ADDENDUM 1
KUSD Bid No. 4904 F
KENOSHA UNIFIED SCHOOL DISTRICT (KUSD)
Lakeview K-8 Academy
68th St Vacation, Pick-up / Drop-off Loop Construction
6811 18th Avenue, Kenosha WI
November 12, 2025

CONSTRUCTION PLANS
for
LAKEVIEW K-8 ACADEMY
68th St. VACATION & PICK-UP/DROP-OFF LOOP
SITE GRADING, DRAINAGE, UTILITY,
& PAVEMENT IMPROVEMENTS
for
KENOSHA UNIFIED SCHOOL DISTRICT
6811 18th Avenue, Kenosha, Wisconsin

ADDENDUM NO. 1

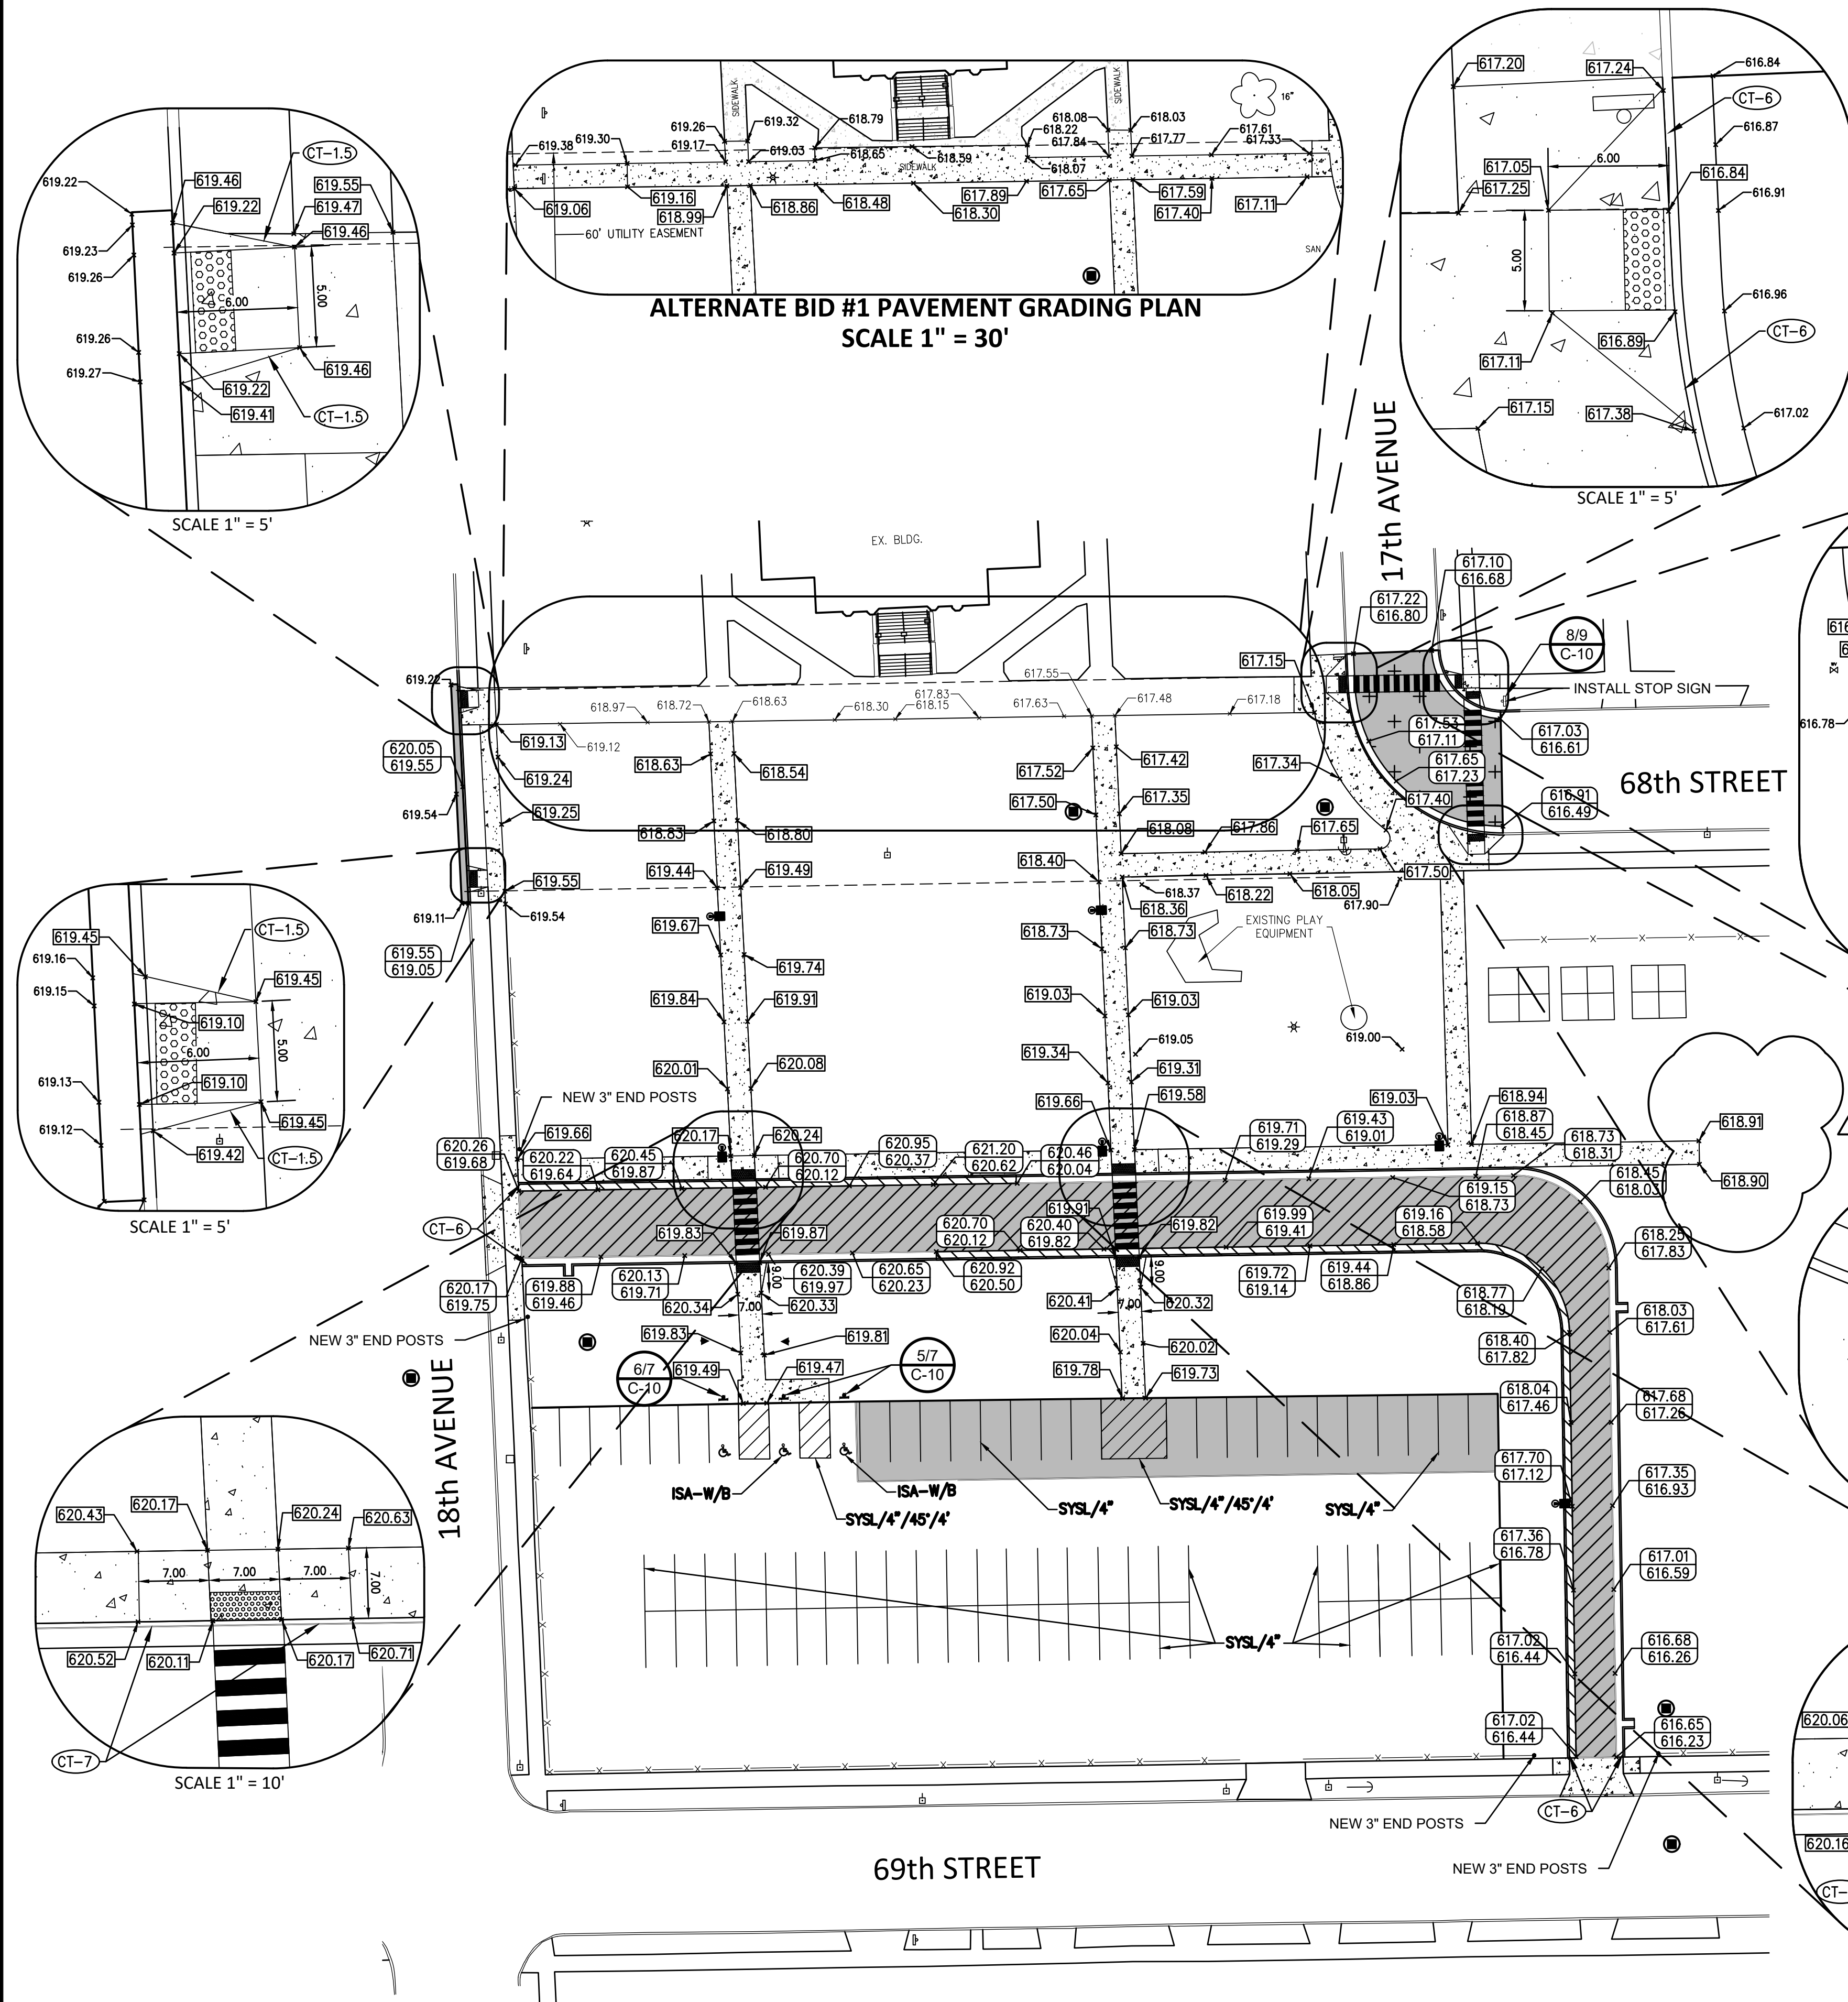
SHEET C-7

- Rim / invert data has been added / updated for OCS's 2.0, 4.0, and 5.0.
- The design has been updated between STM MH 1.0 and OCS2.0.

PROJ. MGR: MDE
DRAFTED: IPL
DATE: 11-3-2025
CHECKED: MDE
DATE: 11-3-2025
2025.0008.01
SHEET
C-11

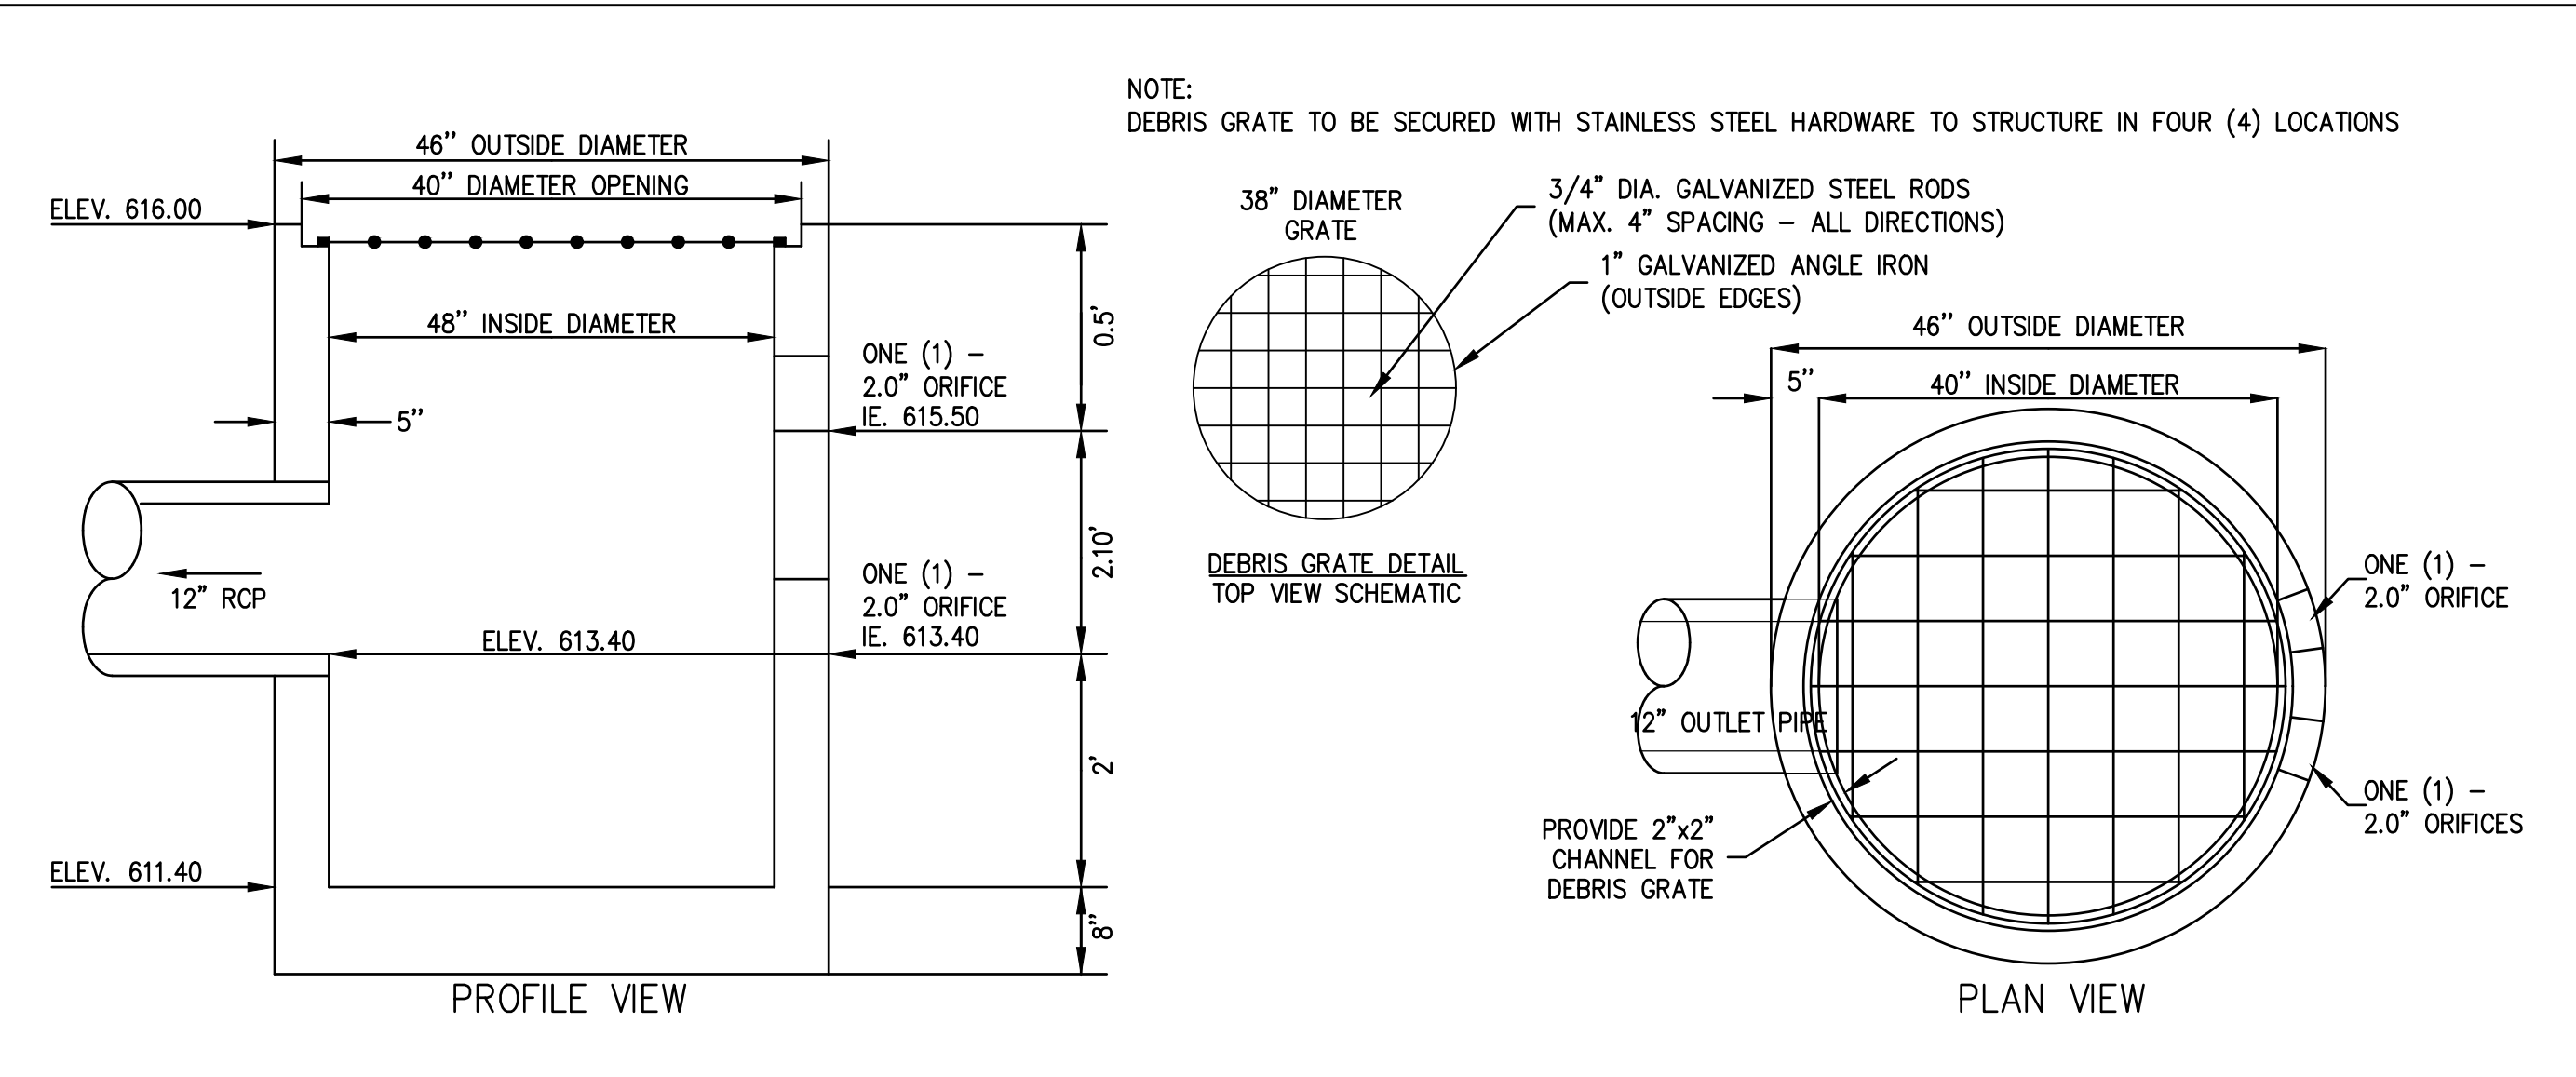
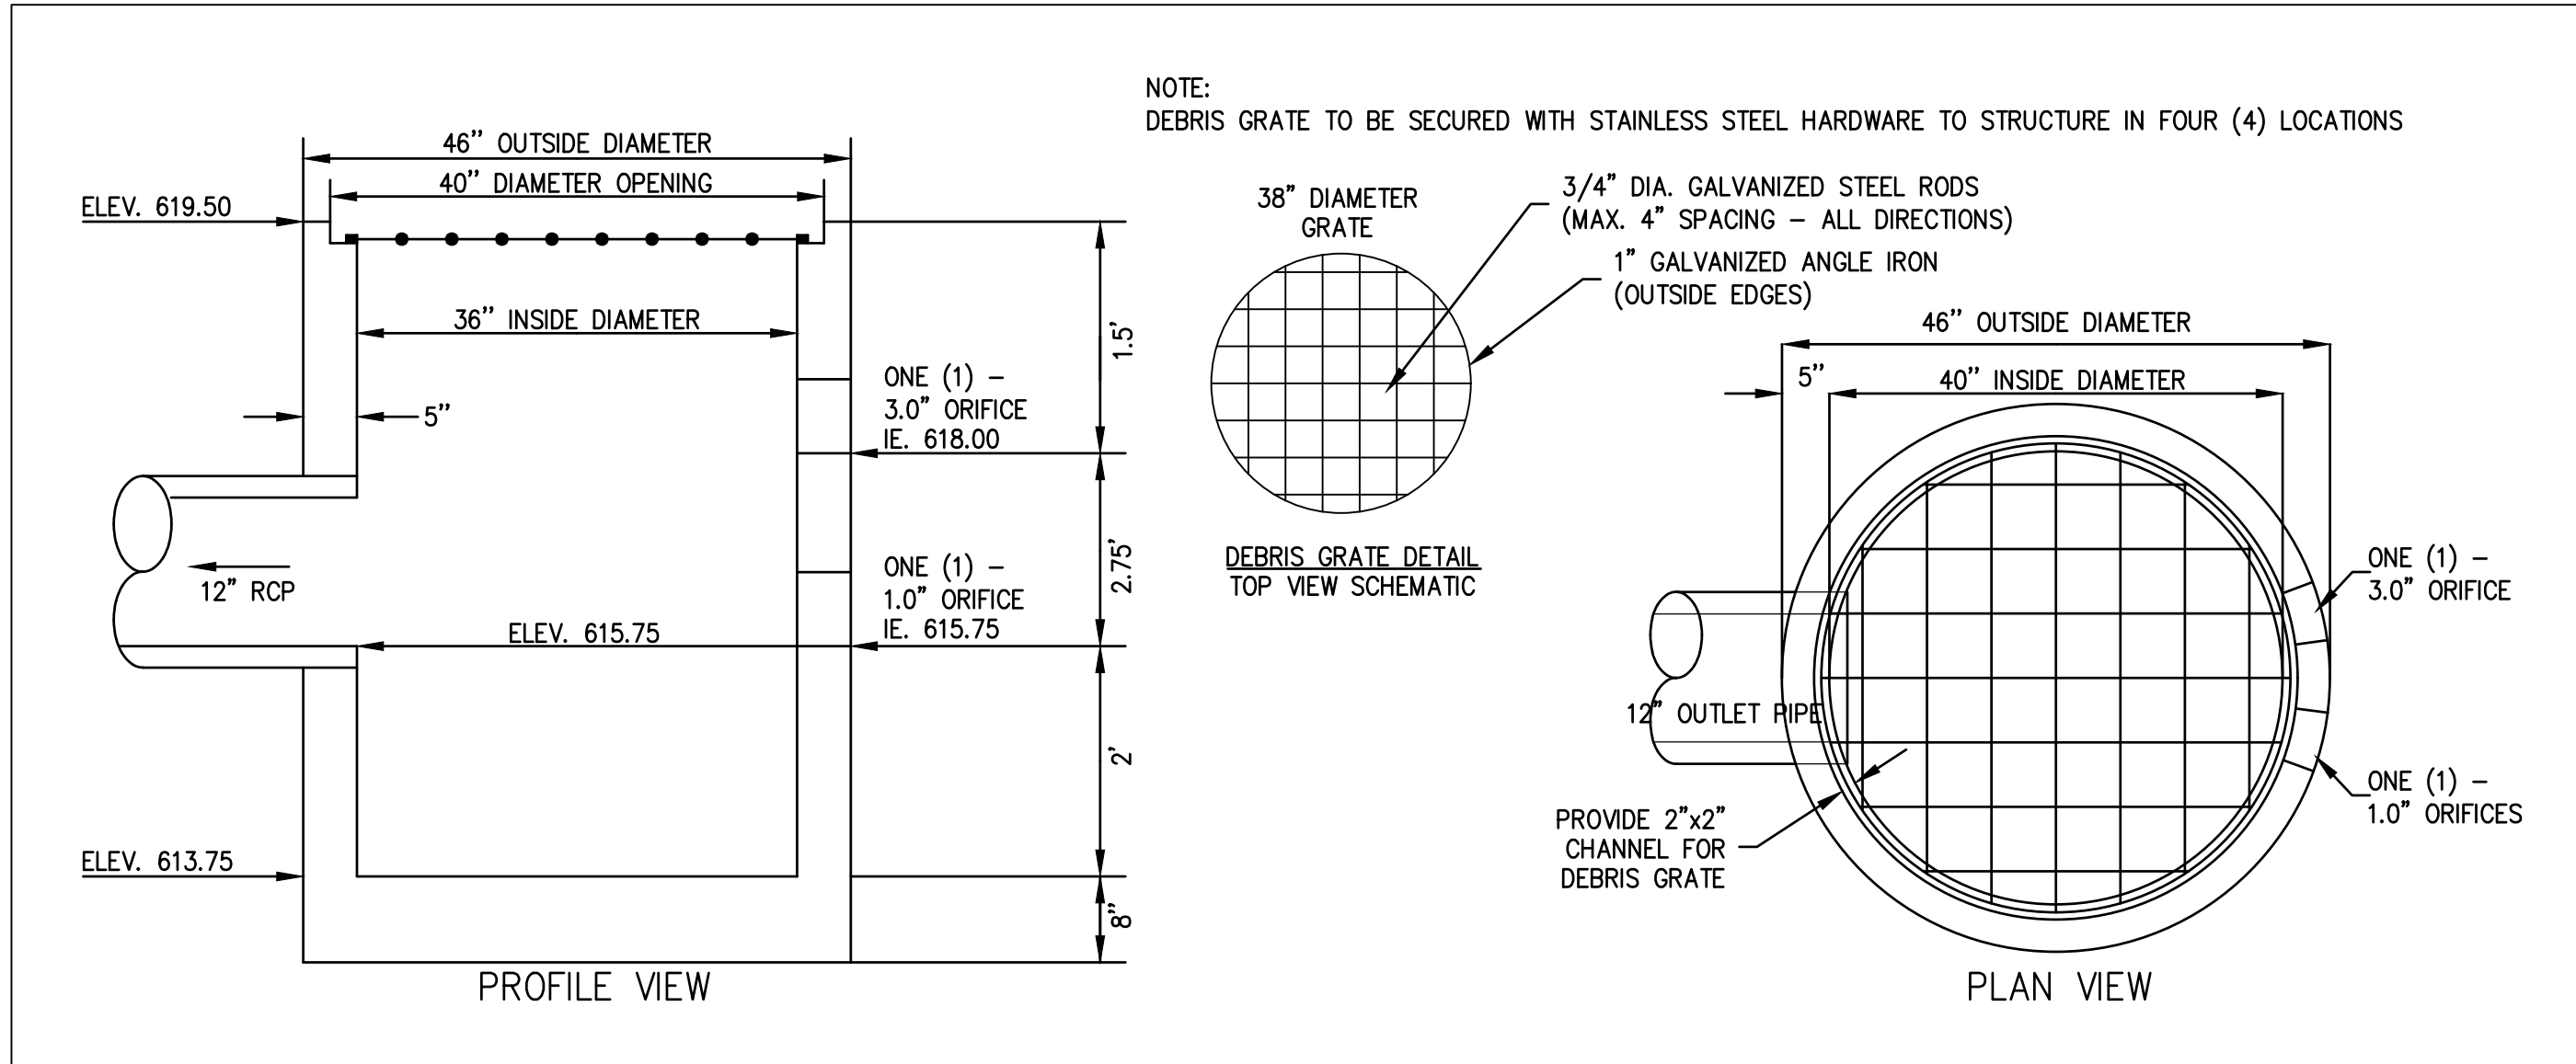
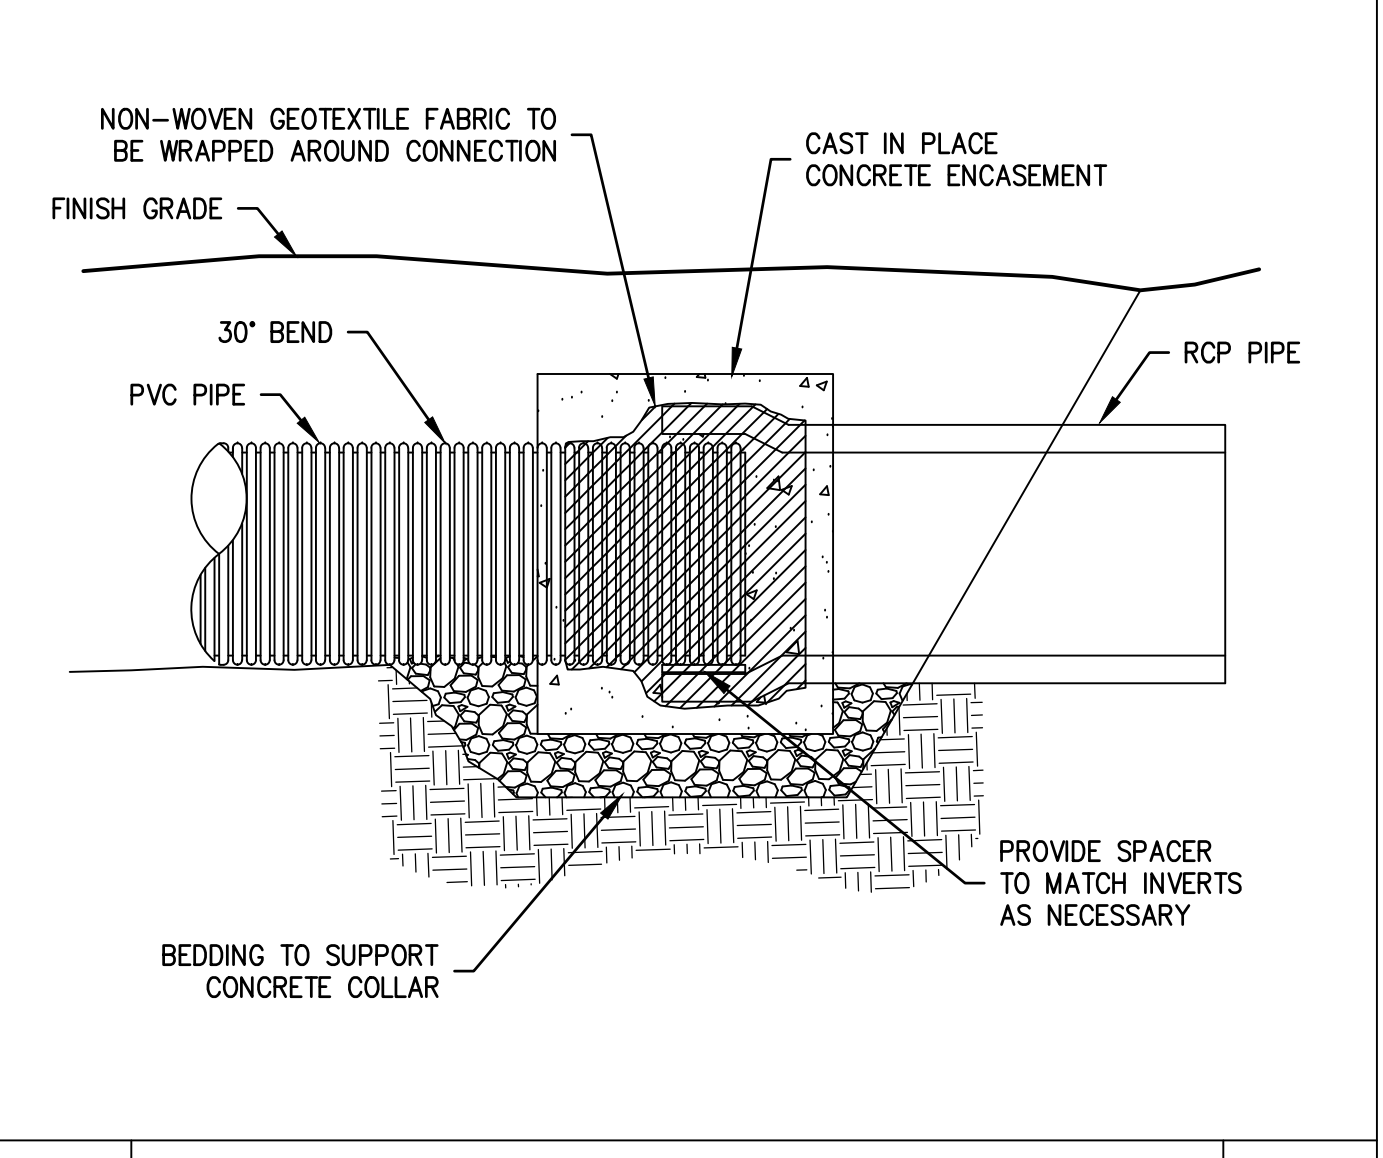
SHEET C-11

- Sheet C-11 has been added which contains the construction details for OCS's 2.0, 4.0, and 5.0.
- A construction detail has been added for the RCP / PVC pipe transition Between STM MH 1.0 and OCS2.0.
